**ROCKFORD BOARD OF EDUCATION
INVITATION FOR BID ON SUPPLIES, MATERIALS, EQUIPMENT OR SERVICES
FOR SCHOOL DISTRICT NO. 205
ROCKFORD, ILLINOIS**

IFB No. 22-23 HVAC & Roofing Projects at Lincoln, East, Washington & Flinn Schools

RE: **ADDENDUM NO. 9**

SHEET TITLE
**THIRD FLOOR
DEMOLITION**
**ELECTRICAL
- AREA C**

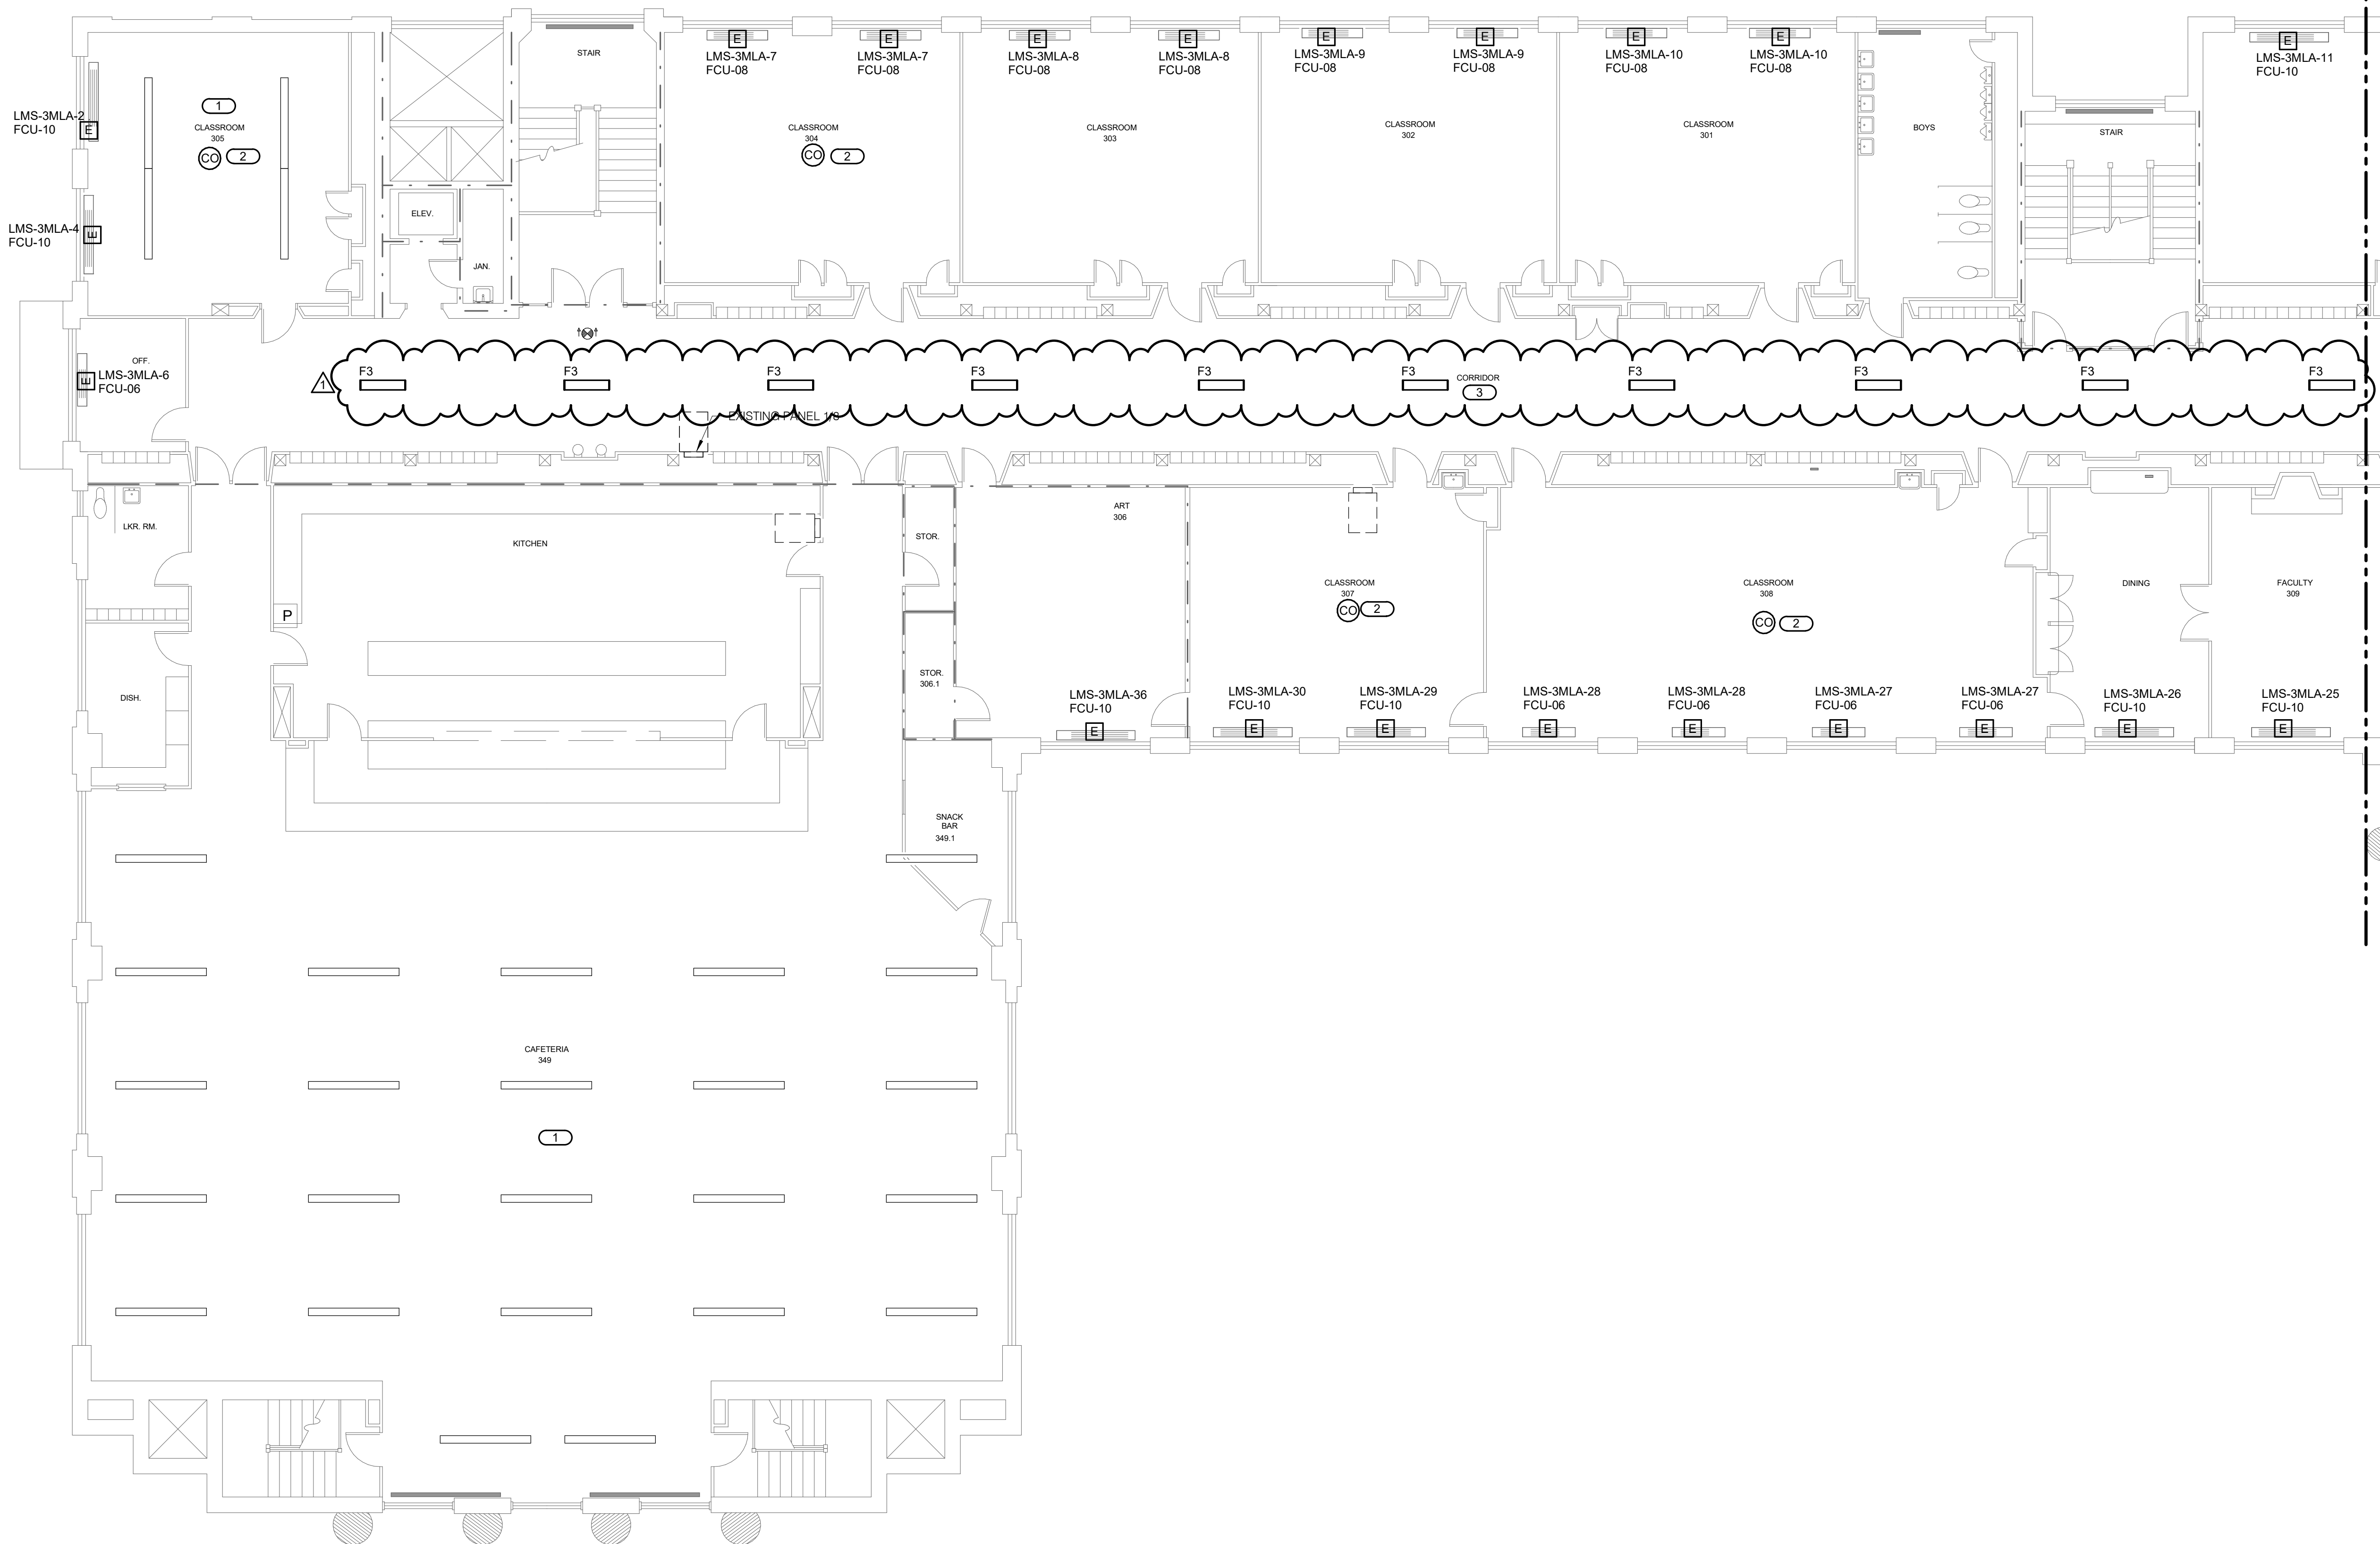
- a. **REVISE** Keynote #2 as shown on revised drawing E105A.
8. DRAWING E105C - THIRD FLOOR DEMOLITION - ELECTRICAL - AREA C
 - a. **REVISE** Keynote #2 as shown on revised drawing E105C.

A2.03A

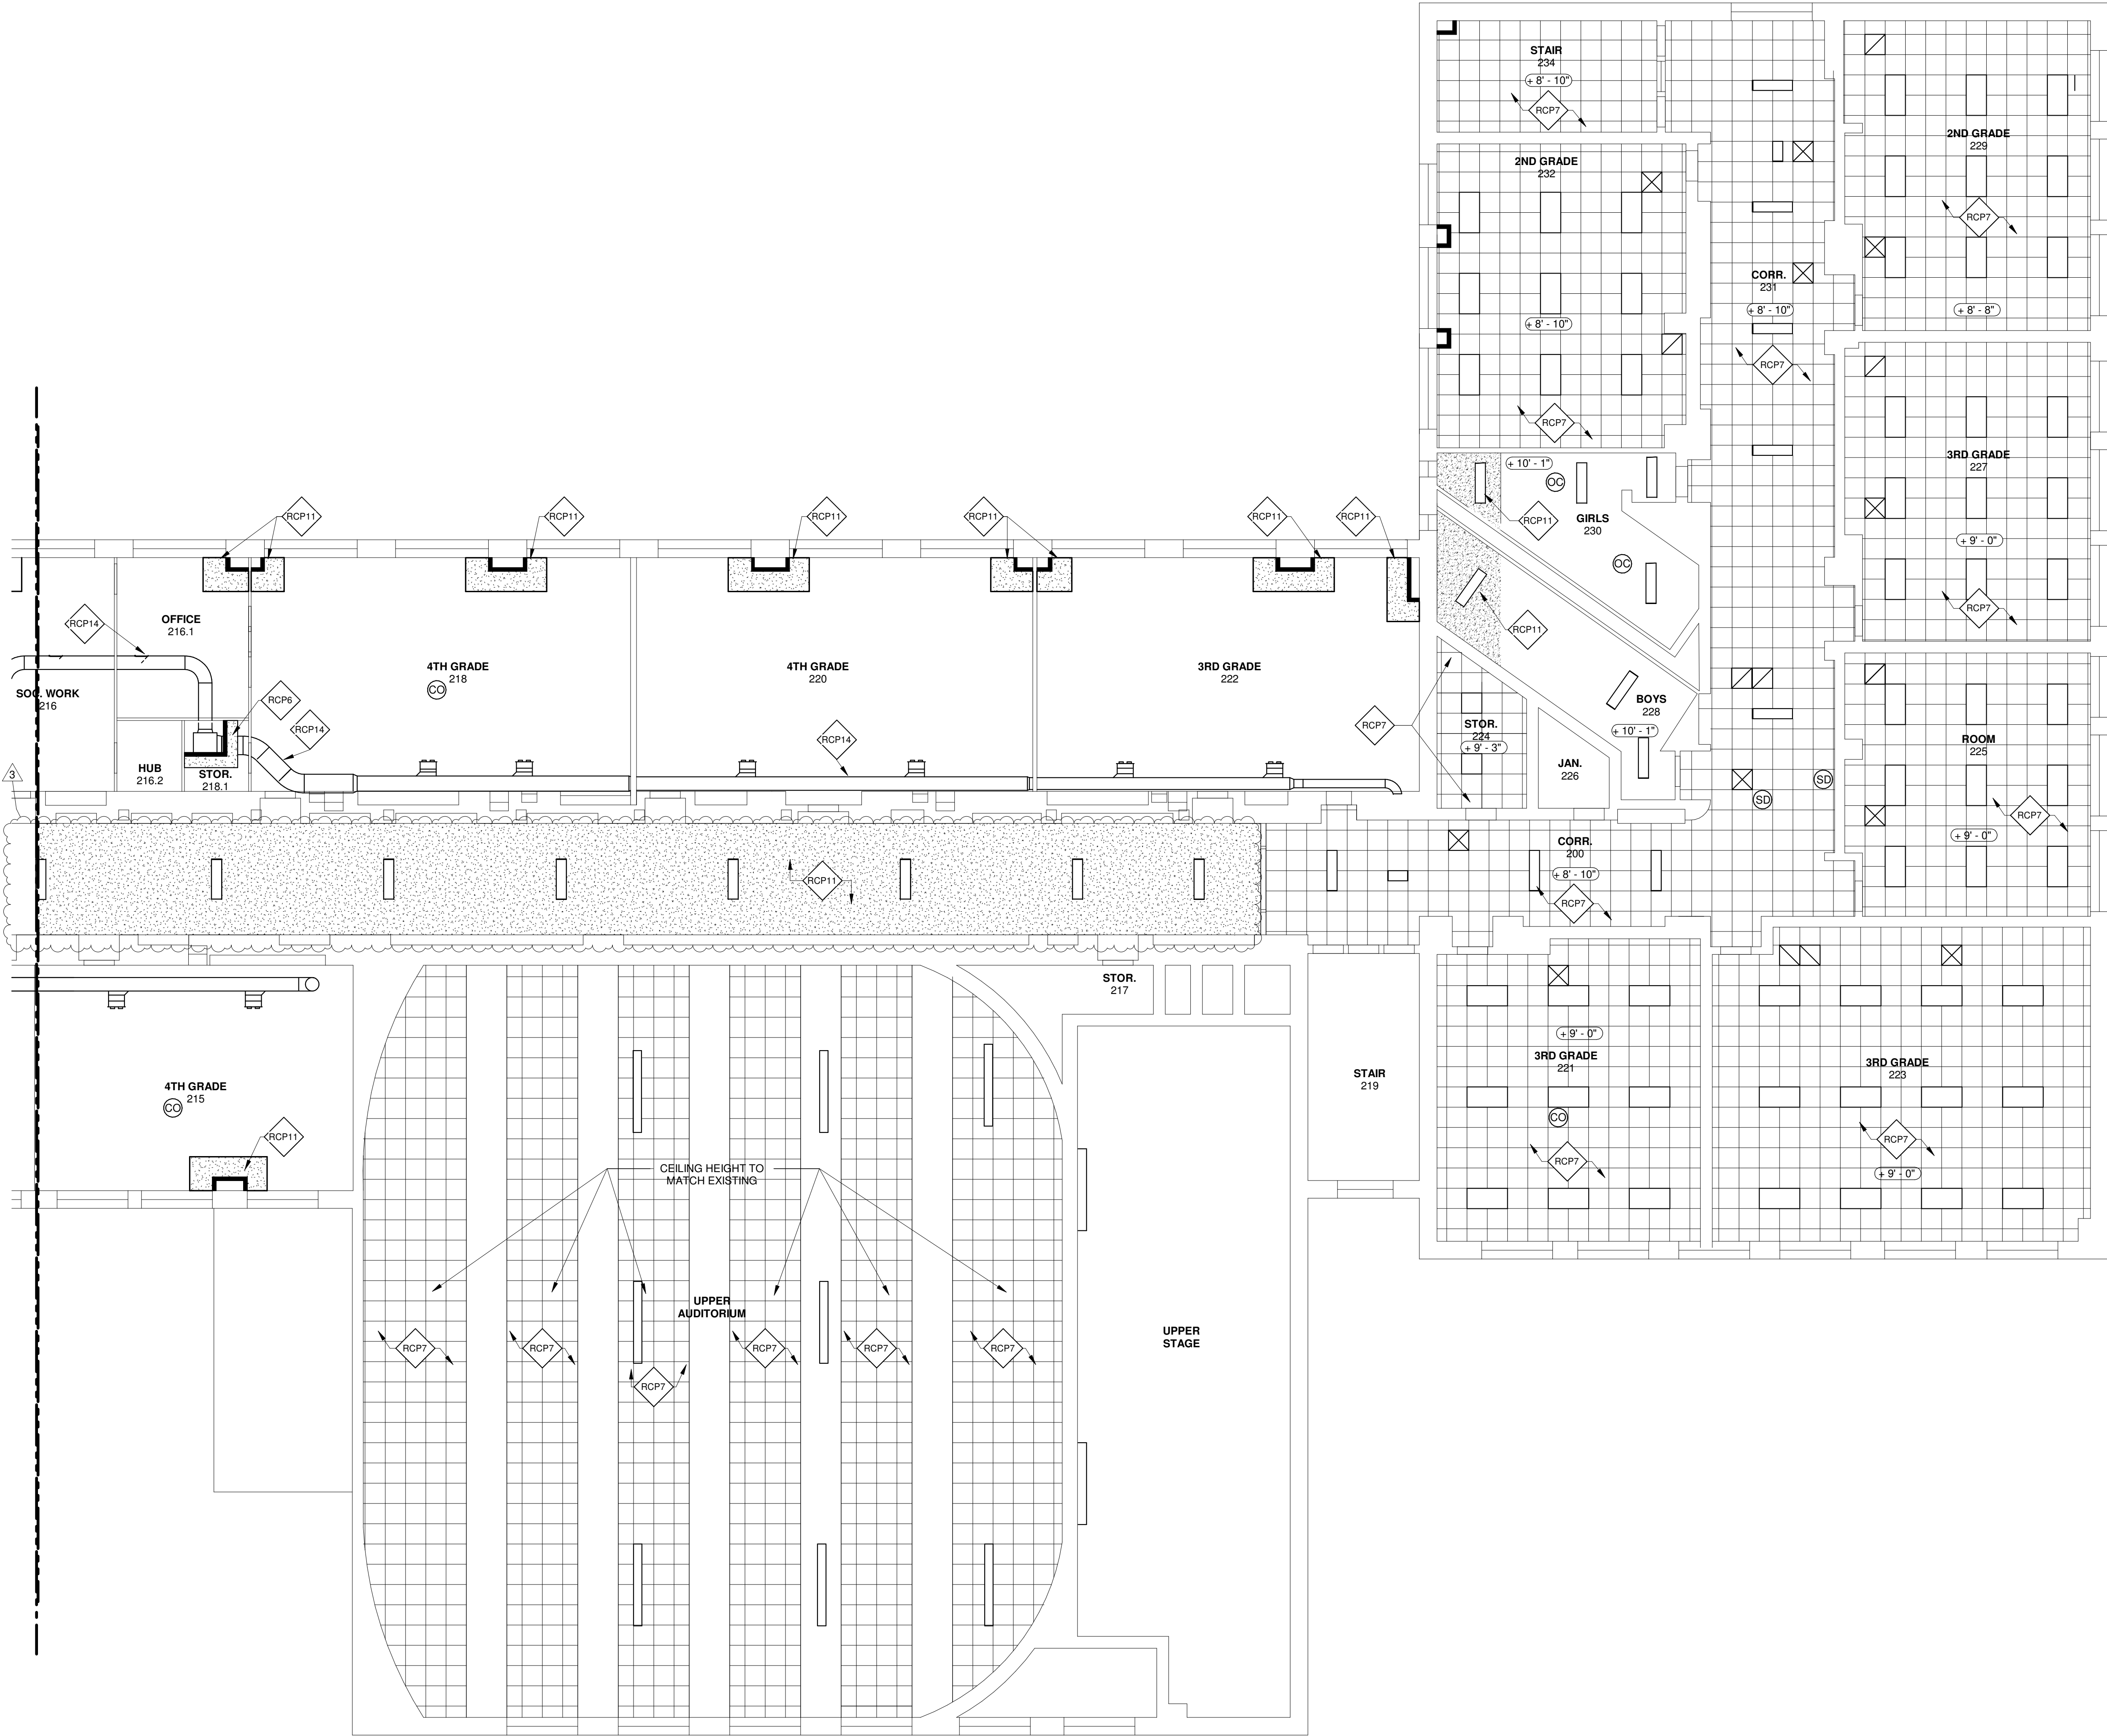
14. DRAWING A2.03A THIRD FLOOR REFLECTED CEILING PLAN – AREA A **REPLACE** entire sheet with A2.03A THIRD FLOOR REFLECTED CEILING PLAN – AREA dated 03/10/2022.
 - a. **REVISE** ceiling system at Corridor 200. Change from Acoustic Ceiling Tile to Gypsum Board.
15. DRAWING A2.03B THIRD FLOOR REFLECTED CEILING PLAN – AREA B **REPLACE** entire sheet with A2.03B THIRD FLOOR REFLECTED CEILING PLAN – AREA dated 03/10/2022.
 - a. **REVISE** ceiling system at Corridor 200. Change from Acoustic Ceiling Tile to Gypsum Board.

FIRST FLOOR DEMOLITION PLAN - AREA D

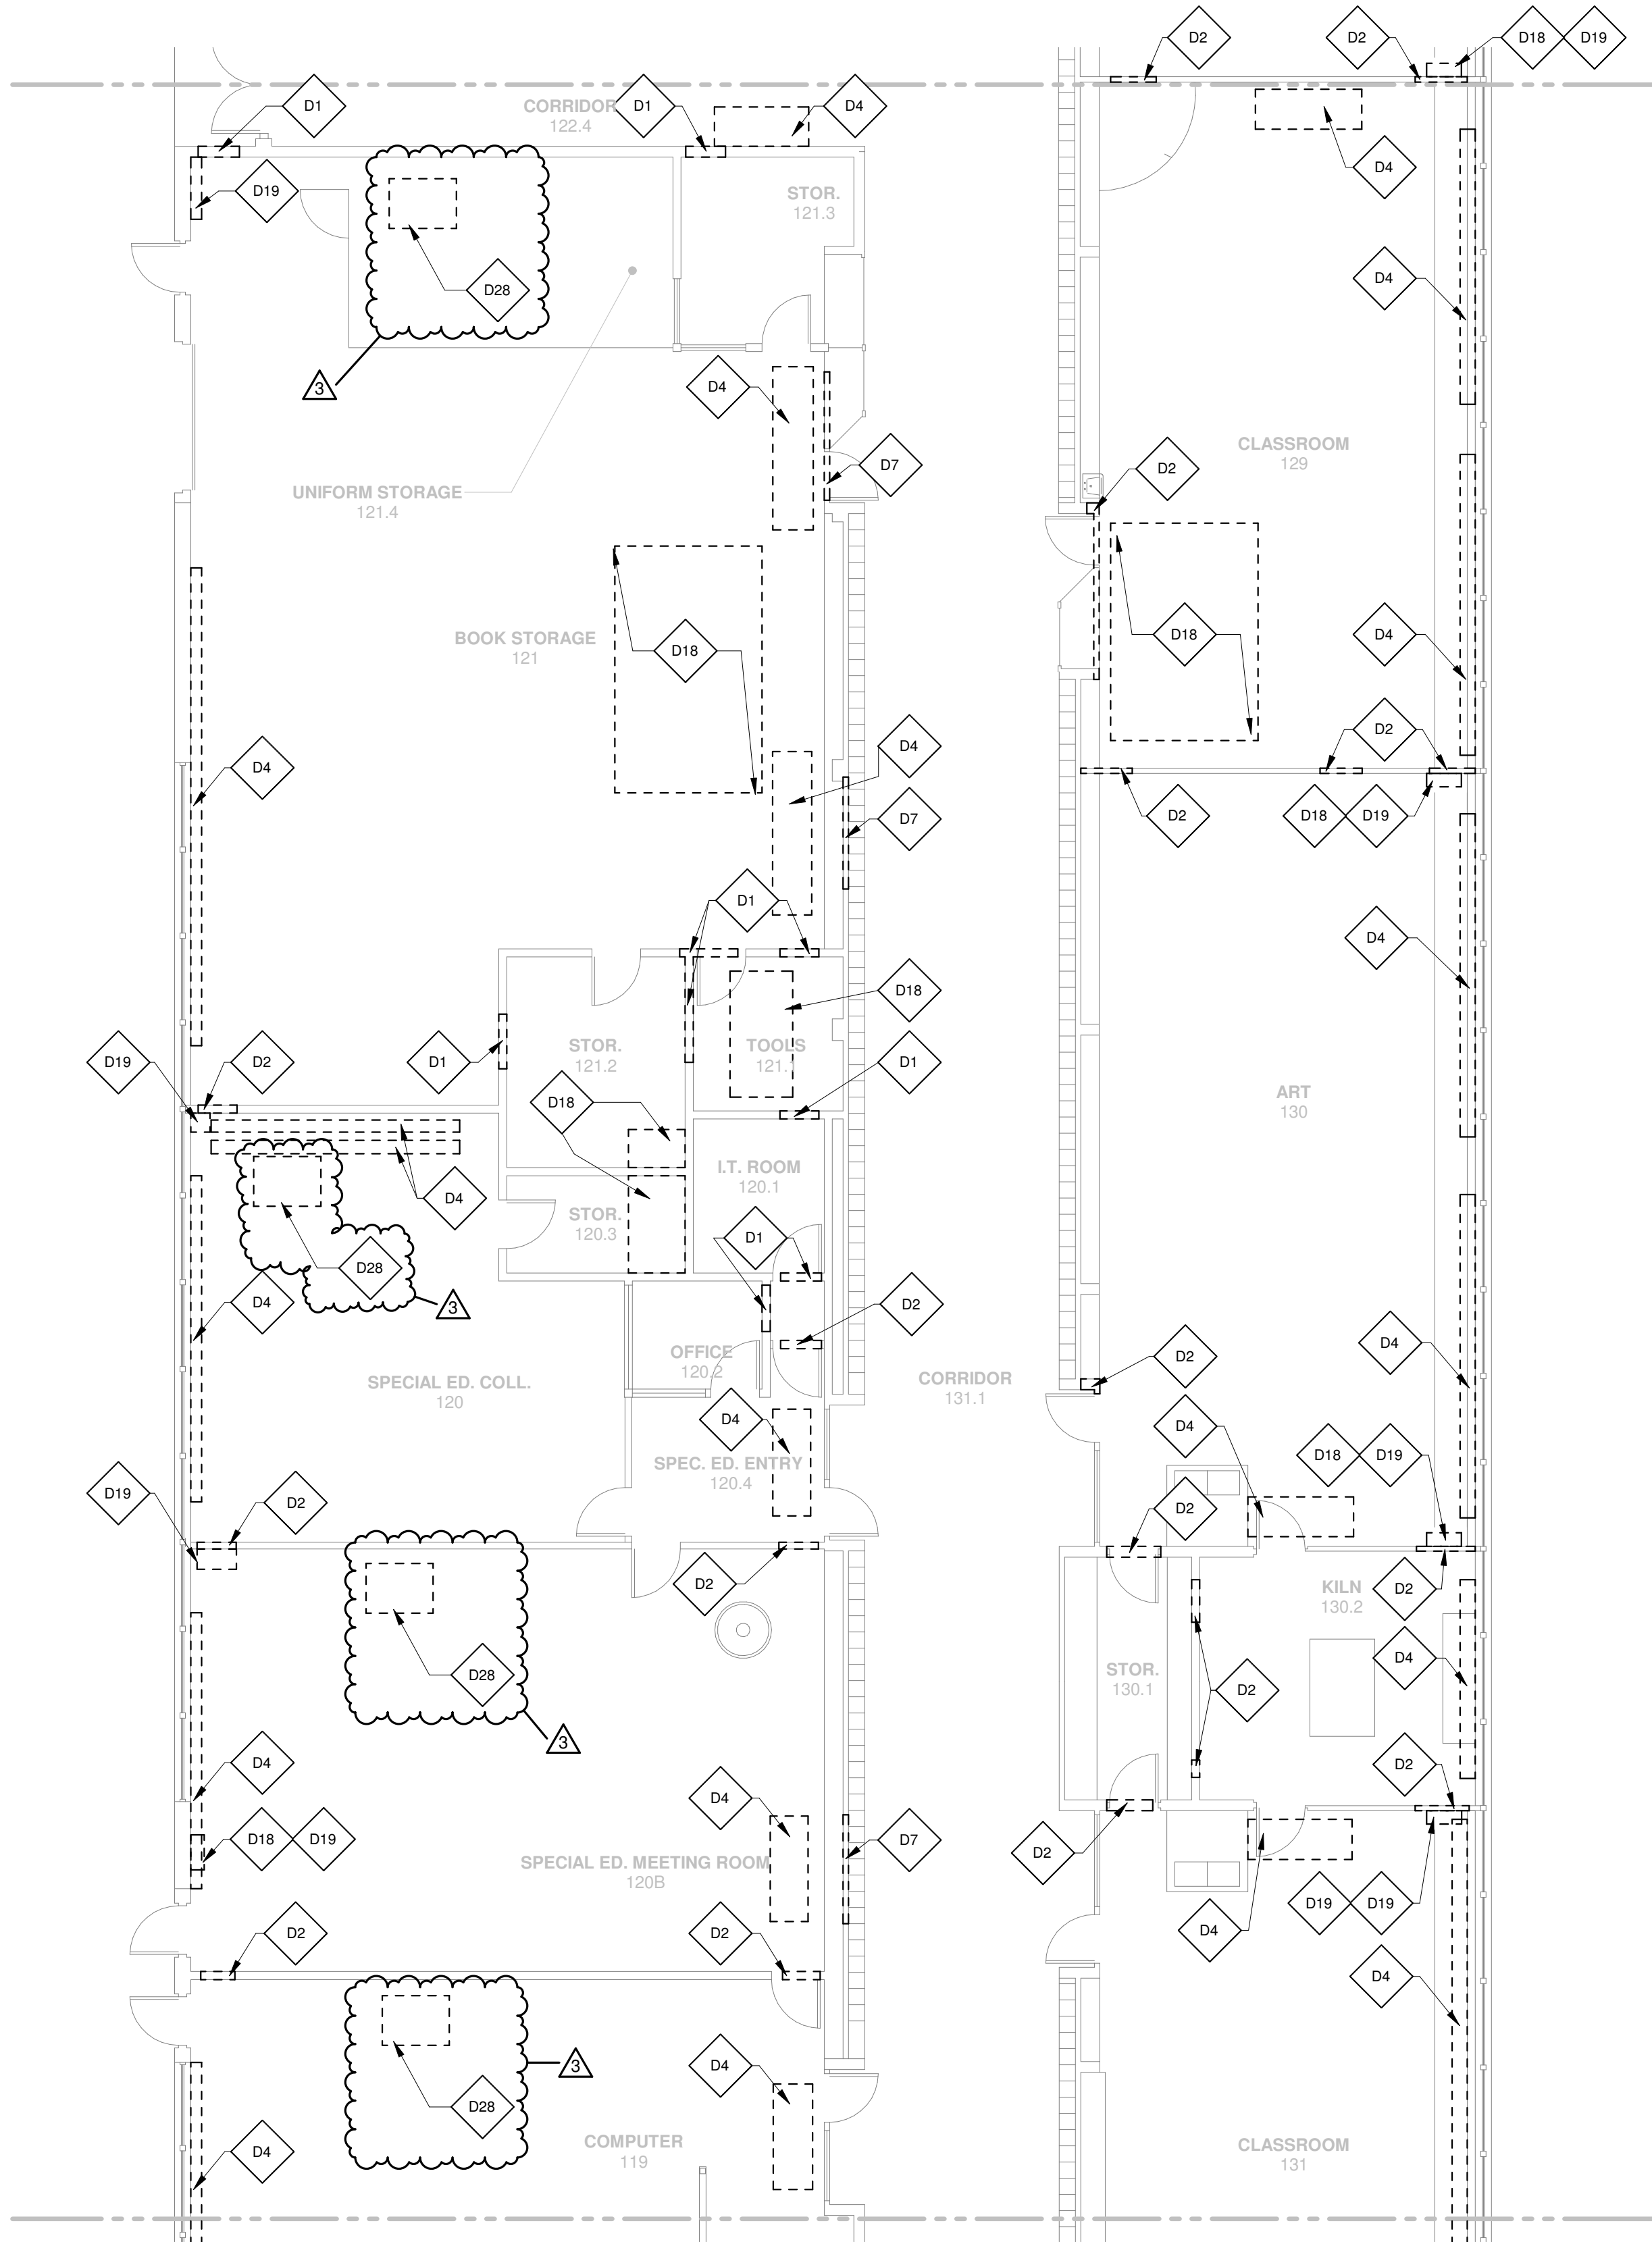
16. DRAWING D1.01D – FIRST FLOOR DEMOLITION PLAN – AREA D **REPLACE** entire sheet with D1.01D – FIRST FLOOR DEMOLITION PLAN – AREA D dated 03/10/2022.
